2. Historic District Commission Meeting Packet 10-23-18

CITY OF YPSILANTI
Agenda
Historic District Commission
Tuesday, October 23, 2018 - 7:00 p.m.
City Hall, Council Chambers, 1 S. Huron
Ypsilanti, MI 48197

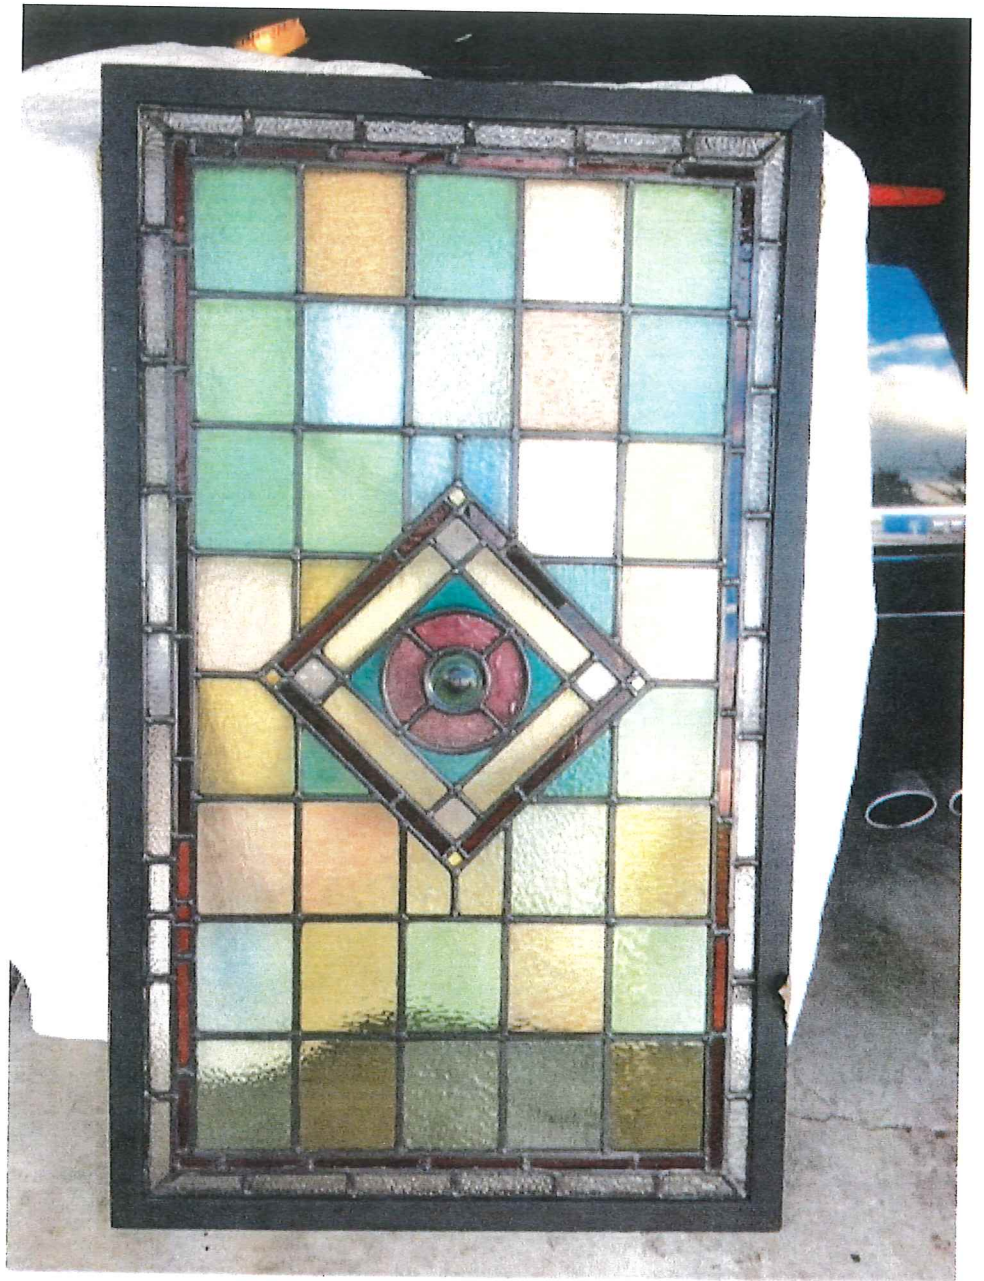
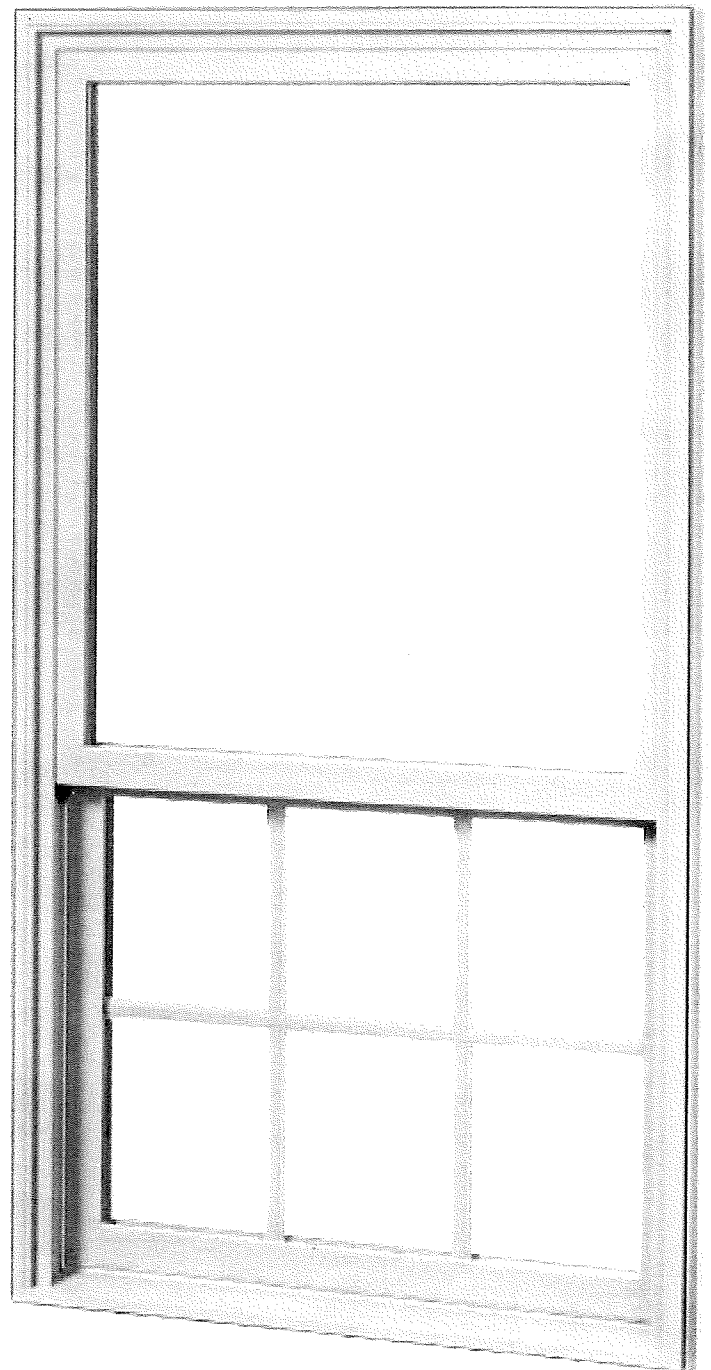
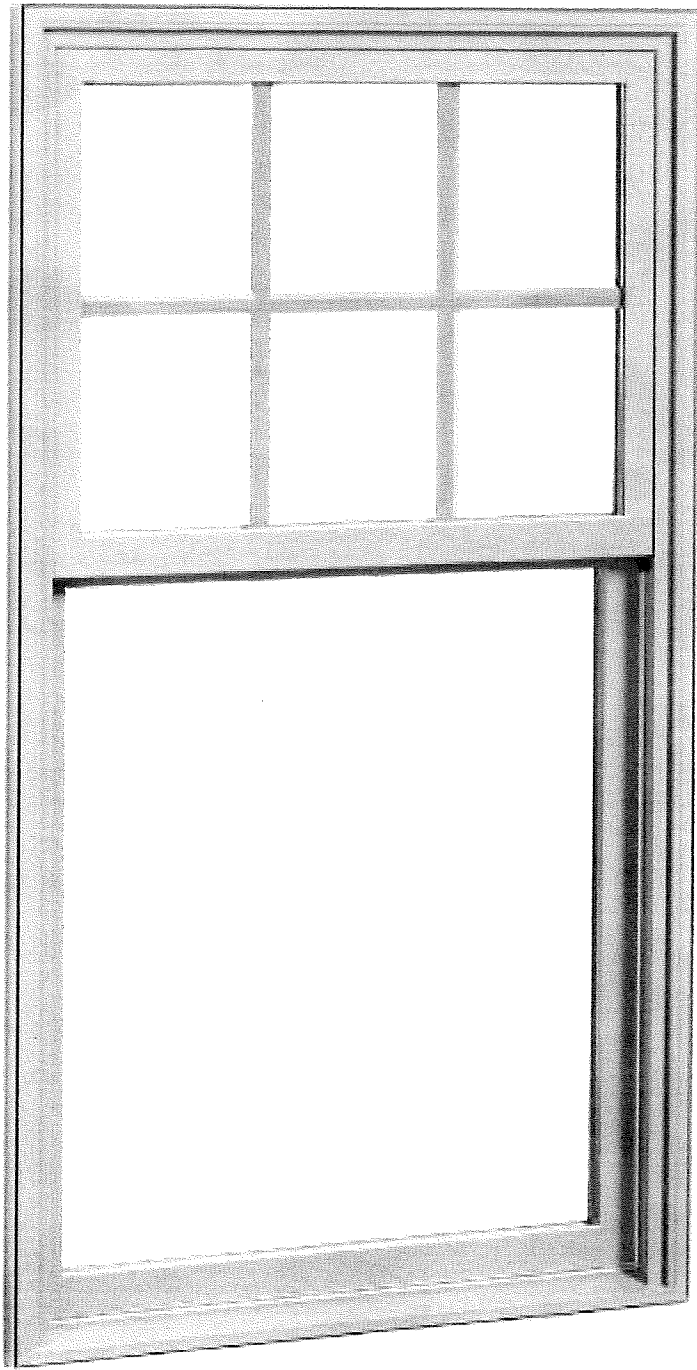
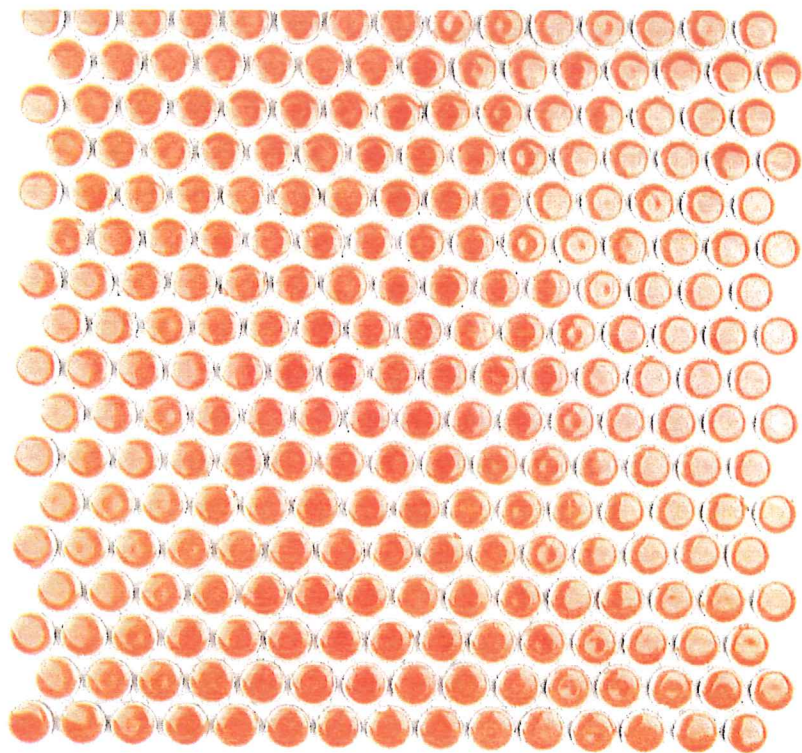
1. The applicant was previously approved for door replacement on the front and the back of the store.
2. The applicant is looking to replace the windows on the front upper level with Pella double hung windows. There is no indication of the model or type of windows on the application; HDC to confirm the type of window to be used. (Pella does make a wood window, however the clad wood windows are only clad in a vinyl or composite material)

4. The applicant appears to indicate that the windows may be finished in brown as well as around the front door. HDC to confirm.
5. The applicant is proposing the stained glass window for above the door; there are no historic photos to support that a stained glass window would have been installed in this location however historically storefronts were modified quite often as is indicated in the historic photo from when the police station was located at this address with a 2nd door in the storefront area.

6. The applicant is planning on installing an orange penny tile above and below the large plate glass storefront window.
7. A building department permit will be required and should be obtained prior to the start of work.
